FORMER ELEMENTARY SITE PARK PLAN **CITY OF DETROIT, OREGON**

SEPTEMBER, 2013

Community
Planning
Workshop

Figure 12.3. Plaza concept poster

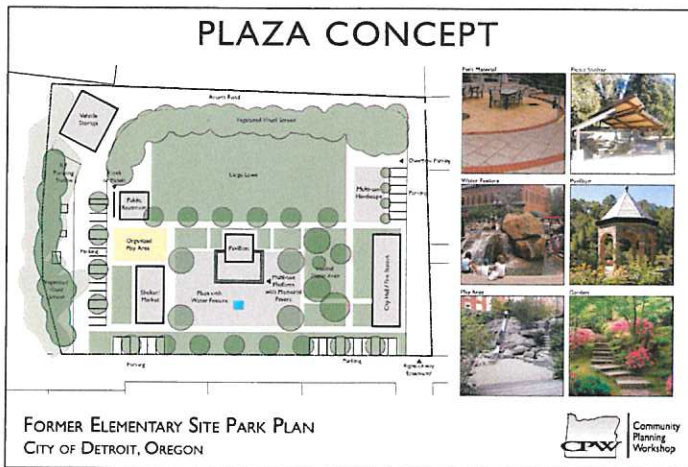
- Paver walkways.
- Paved paths are more accessible. Whole site should be very accessible.
- Small perennial garden.
- Low maintenance plants and informal gardens.
- Flexible seating under picnic shelter.
- Flexible tables and seating for the picnic shelter.
- Seating wall around picnic shelter.
- Steeply pitched roofs for pavilion and picnic shelter.
- Like the wood structures.
- Likes the timber structures for the playground (jungle gym, swings).
- A water feature that kids can play on in the summer and makes sense in the winter (when the water is turned off).

- Village green feels most versatile.
- Group the picnic shelter with restrooms and playground.
- Access to power throughout the site is important for performances and events.
- Make lawn the right size for a landing zone for Life Flight: 100'x100'

- Lawn in front = eyes on the park.
- Parking on south side and split in the middle (like in plaza and organic concepts).
- Likes the lawn in the back of the park.
- Large civic lawn in the front of the site.
- Shade around picnic shelters.

Specific features:

- Organic play area building is scary!
- Plaza is too urban feeling.
- Who manages the RV pumping station? Do we need it?
- No RV dumping, please.
- Need electricity in pavilion.
- No sand in the play area—becomes kitty litter!
- Wood playground would not hold up to weather.
- Not the stone pavilion.

- Fire station should be oriented along the street or at a diagonal.
- Drive-through design for the fire station.
- Would like a two-story firehall. (I WANT A FIRE POLE.)
- Pavilion should be in a more intimate area, like the shaded picnic area.
- Pavilions don't work for stage areas—these two uses need to be separated to provide for good sound at events.
- Shute Park in Hillsboro has a good precedent for a working permanent stage area.

Figure 13. Conceptual plan drawing

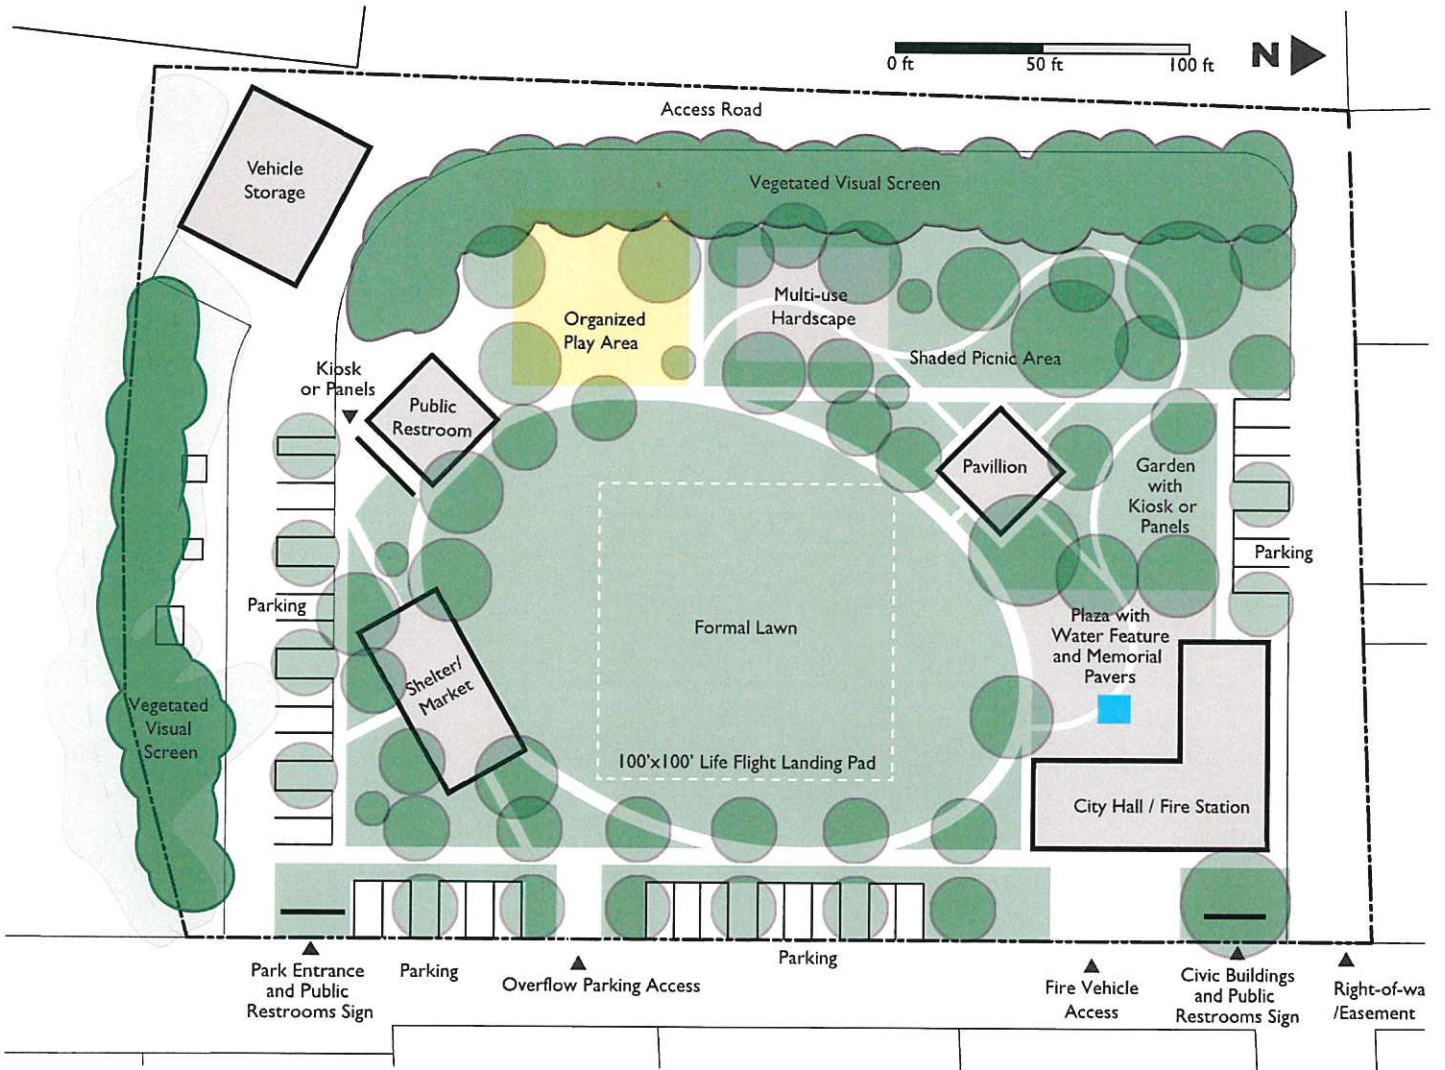
- The multi-use hardscape element should include a basketball hoop.
- There should not be a separate skate-park element but the plaza should be designed to accommodate, not repel, skateboard users.
- Electrical outlets should be available throughout the site to accommodate community events.
- The location of the public restrooms should be moved to the southeast corner to most easily accommodate the needs of motorists. The location should be swapped with the location of the picnic/market shelter.
